KUDZ ZE KAYAH PROJECT

RESPONSE #3 TO YESAB EXECUTIVE COMMITTEE INFORMATION REQUEST KZK

June 2018

FIGURE 6-1
POTENTIAL AVAILABLE HABITAT UPSTREAM
OF THE RCH FOLLOWING THE PROVISION OF
FISH PASSAGE

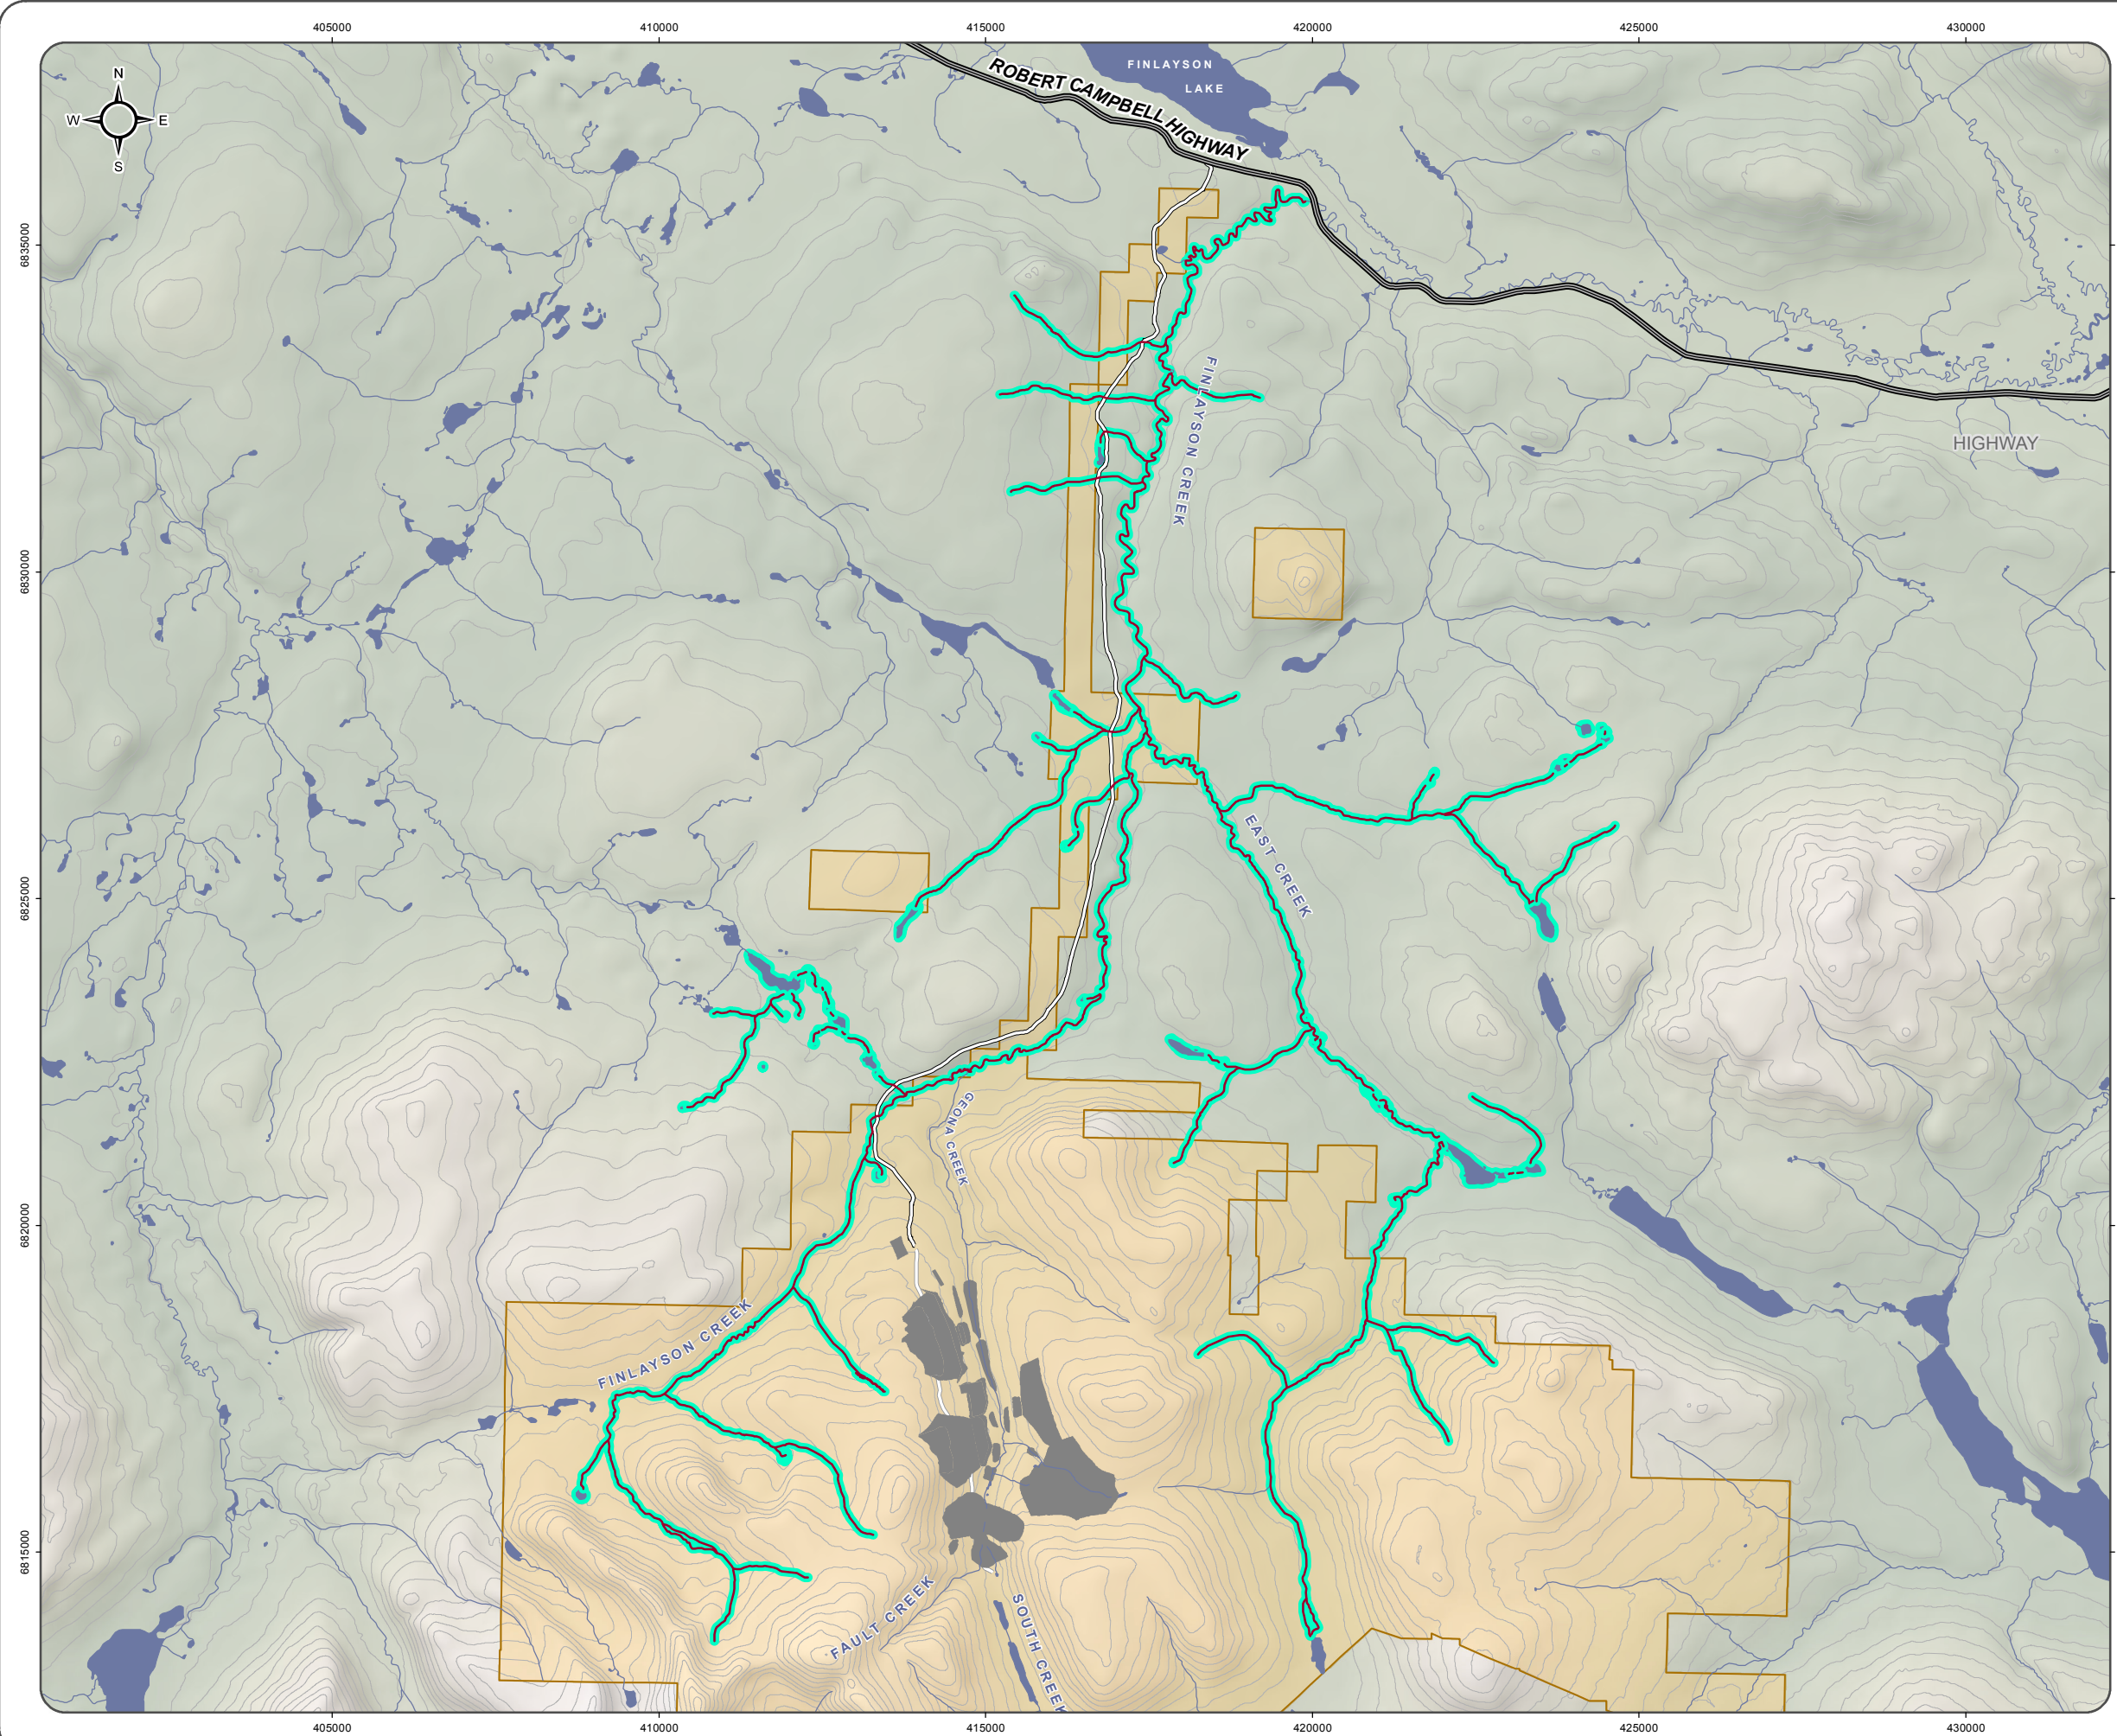
Provide information on the types and amounts of fish habitat to be made accessible by the restoration of fish passage for the Robert Campbell Highway culvert crossing of Finlayson Creek and a habitat assessment of areas of stream habitat to be made accessible.

To offset these losses BMC has proposed to remove the fisheries passage barrier at the RCH on Finlayson Creek as part of the offsetting plan. Preliminary results indicate that potential habitat available upstream of the RCH in Finlayson Creek itself, is a total stream length of 36.56 km and an estimated a total wetted perimeter area of 225.4 km² (Table 6-1; Figure 6-2). Available wetland/pond habitat in the headwaters of Finlayson Creek has a total surface area of 36.47 ha. Although the percentage of Finlayson Creek tributaries that would be accessible to fish following the implementation of the fish passage plan at the RCH is currently unknown, they could provide an additional stream area of 26.63 km², and a total length of 31.51 km.

The largest tributary of Finlayson Creek, East Creek, has an estimated pond/wetland habitat of approximately 48.89 ha (Table 6-1; Figure 6-2). Depending on the presence and location of any impoundments in East Creek, a maximum of 51.24 km² of wetted perimeter surface area and a total length of 18.02 km could become accessible to migratory fish and its tributaries could provide an additional wetted perimeter area of 19.10 km², with a length of 24.28 km.

Figure 6-4: Construction - Difference (%) Between Baseline and Monthly Runoff for Mean Scenario

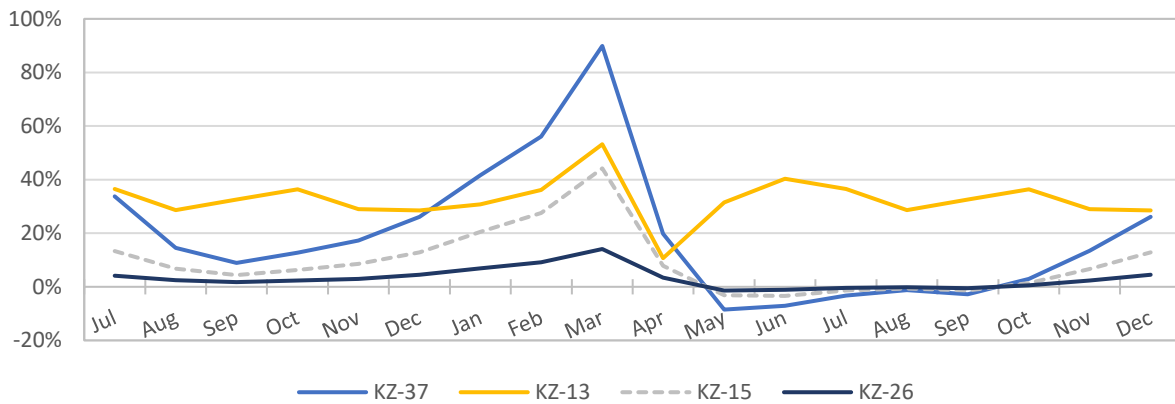
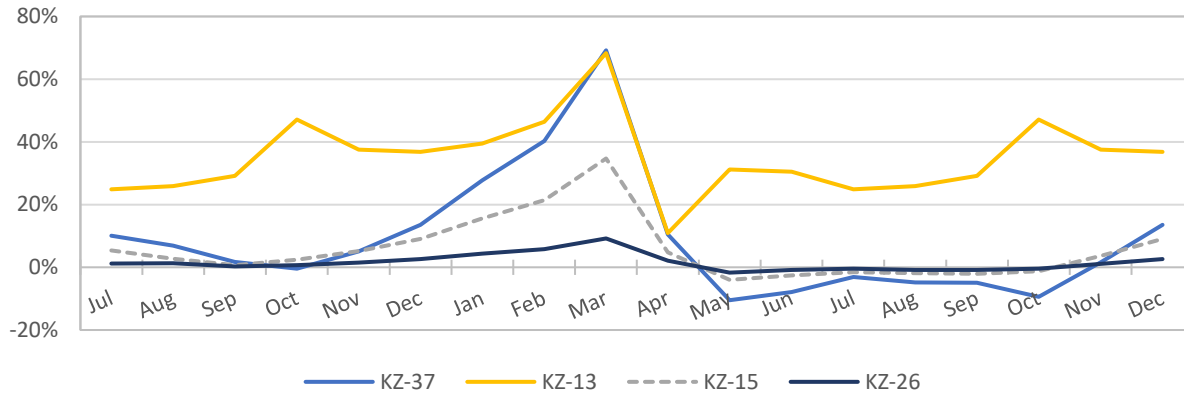
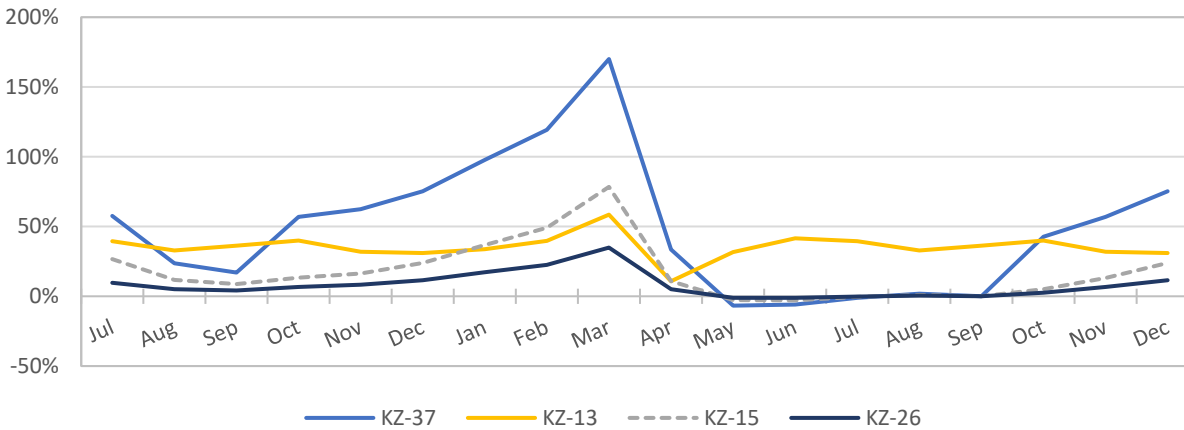
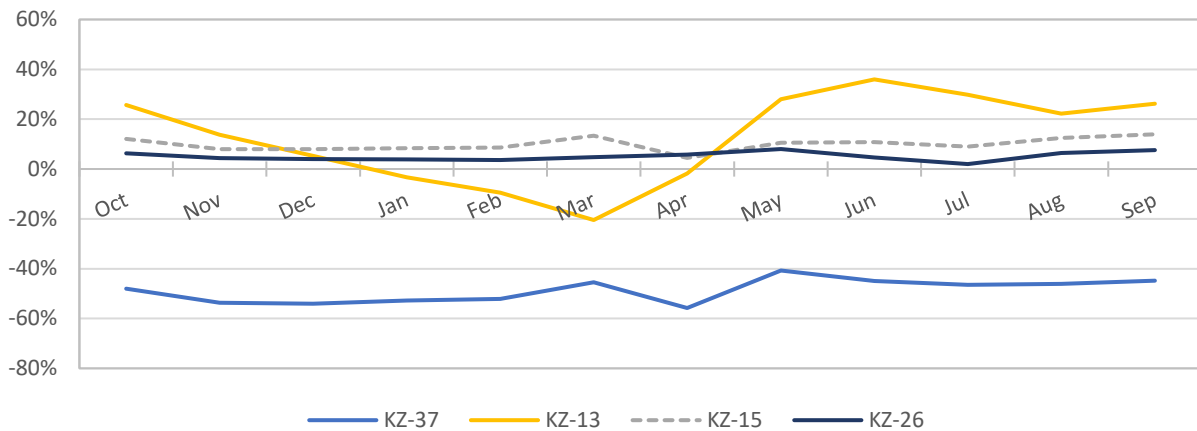
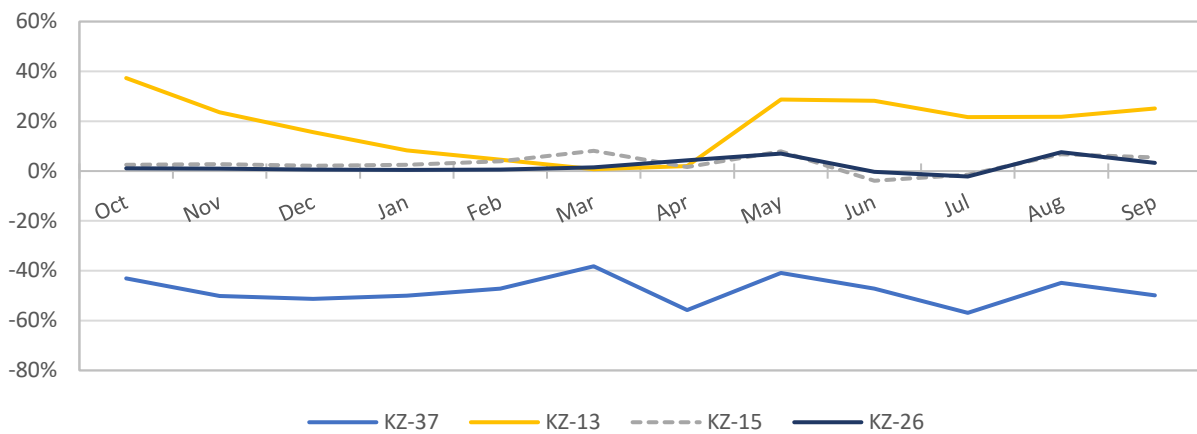
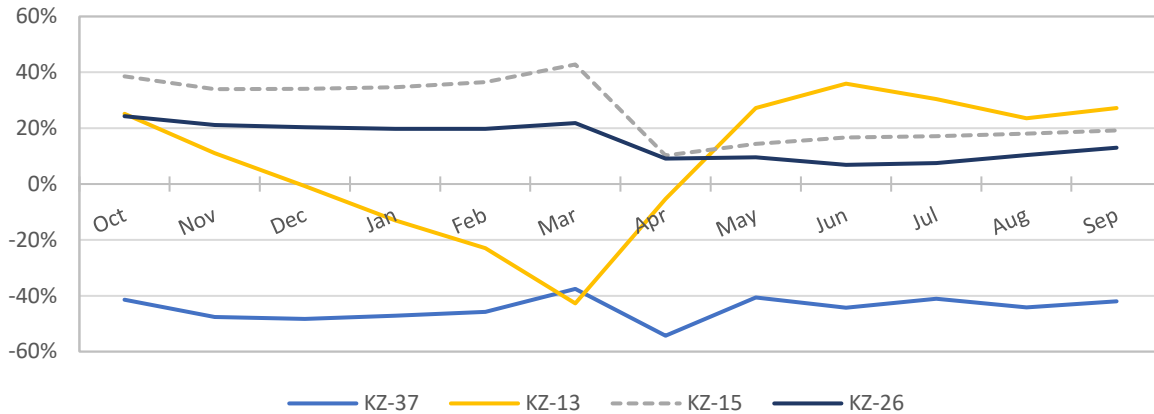
In order to understand the potential impacts to fish habitat from flow alterations, the following information is requested: the monthly percent change in flow from existing conditions at each phase in flow changes and at a series of locations within impacted watercourses to demonstrate downstream attenuation and extent; a consideration of and accounting for potential effects between each phase of flow alterations; Information on the magnitude and areal extent (m²) of altered fish habitat likely resulting in negative impacts to fish or fish habitat, including an accounting of this area by habitat type and reach.

Figure 6-4, Figure 6-5 and Figure 6-6 illustrate how flows are predicted to be altered (monthly % difference) on Geona, South and Finlayson Creeks during a mean, 1/50 wet and 1/10 dry year respectively during the construction phase of the Project.

Figure 6-7, Figure 6-8 and Figure 6-9 illustrate how flows are predicted to be altered (monthly % difference) on Geona, South and Finlayson Creeks during a mean, 1/50 wet and 1/10 dry year respectively during the operations phase of the Project.

The predicted change to baseline flow in lower Geona Creek due to mining activity vary depending on the phase of development (construction, operations or closure) and type of year with respect to precipitation rates as illustrated in Figure 6-4 to Figure 6-15 above.
